United Nations ECE/TRANS/WP.29/GRSP/2018/9

Collective amendments to UN Regulations Nos. 16, 94 and 137

Submitted by the expert from the International Organization of Motor Vehicle Manufacturers*

I. Proposal for the 08 series of amendments to UN Regulation No. 16 (Safety-belts)

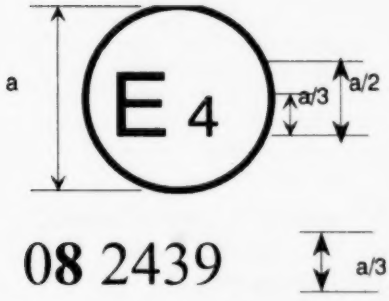
The belt bearing the above approval mark is part of a restraint system ("Z"), it is a special type belt ("S") fitted with an energy absorber ("e"). It has been approved in the Netherlands (E4) under the number 0824391, the Regulation already incorporating the 08 series of amendments at the time of approval.

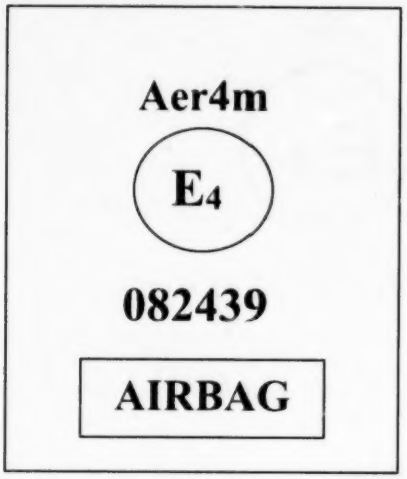
The safety-belt bearing this type-approval mark is a three-point belt ("A") fitted with an energy absorber ("e"), approved as meeting the specific requirements of paragraph 6.4.1.3.3. of this Regulation, and with a multiple-sensitivity ("m") type 4 ("r4") retractor, in respect of which type approval was granted in the Netherlands ("E4") under the approval number 082439. The first two digits indicate that the Regulation already incorporated the 08 series of amendments at the time of the approval. This safety-belt has to be fitted to a vehicle equipped with an airbag in the given seating position."
